# Access Compliance Report

## Public Rights-of-Way

Intersection ID: 10036288	Main Street: ROSE_RIDGE_PL	Cross Street: N/A	Location: NE
ADA ID: FDFC946B99D5	Ramp Type: Perp	Initial Pass/Fail: Fail	Overall Compliance: No
Severity Score: 13.75			
Codes/Mitigation Info/Possible Solution		Field Measurements/Component Compliance

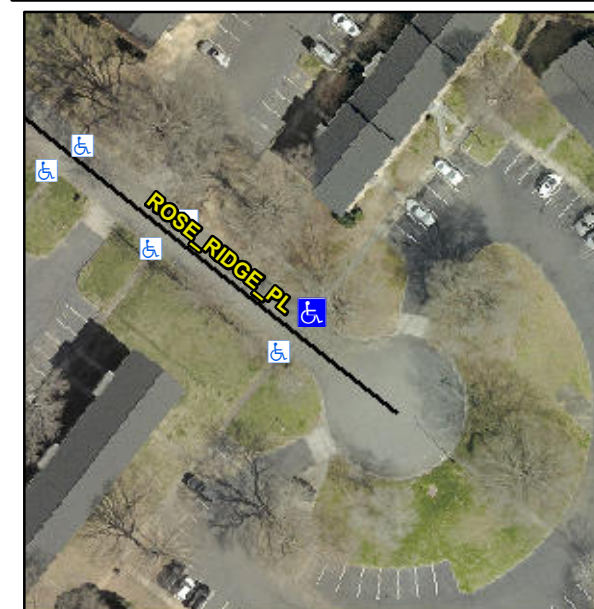
**Remove & Replace Entire Ramp.**

**Not Found, R304.2.2**

Compliance	Description	Data	Compliance	Description	Data
N/A	Ramp Length (in)	43.0	No	Ramp Slope (%)	11.7
Yes	Ramp Width (in)	48.0	Yes	Ramp XSlope (%)	2.7
N/A	Flare Type LT	N/A	N/A	Flare Type RT	N/A
N/A	Flare Slope LT (%)	N/A	N/A	Flare Slope RT (%)	N/A
N/A	Flare Traversable LT?	N/A	N/A	Flare Traversable RT?	N/A
N/A	Landing Length (in)	N/A	N/A	DWS Provided?	N/A
N/A	Landing Width (in)	N/A	N/A	DWS Contrast?	N/A
N/A	Landing Slope (%)	N/A	N/A	DWS Length (in)	N/A
N/A	Landing X Slope (%)	N/A	N/A	DWS Full Width?	N/A
N/A	Landing Curb? (Y/N)	N/A	N/A	DWS Offset (in)	N/A
N/A	Shared Landing?	N/A			
N/A	Gutter Ponding?	N/A	N/A	Gutter Slope (%)	N/A
N/A	Gutter Lip Ht (in)	2.0	N/A	Gutter X Slope (%)	N/A
N/A	Painted X Walk1?	No	N/A	Painted X Walk2?	N/A
	X Walk 1 Direction	To SW		X Walk 2 Direction	N/A
N/A	X Walk 1 Width (in)	N/A	N/A	X Walk 2 Width (in)	N/A
	X Walk 1 Slope (%)	5.0		X Walk 2 Slope (%)	N/A
	X Walk 1 X Slope (%)	3.3		X Walk 2 X Slope (%)	N/A
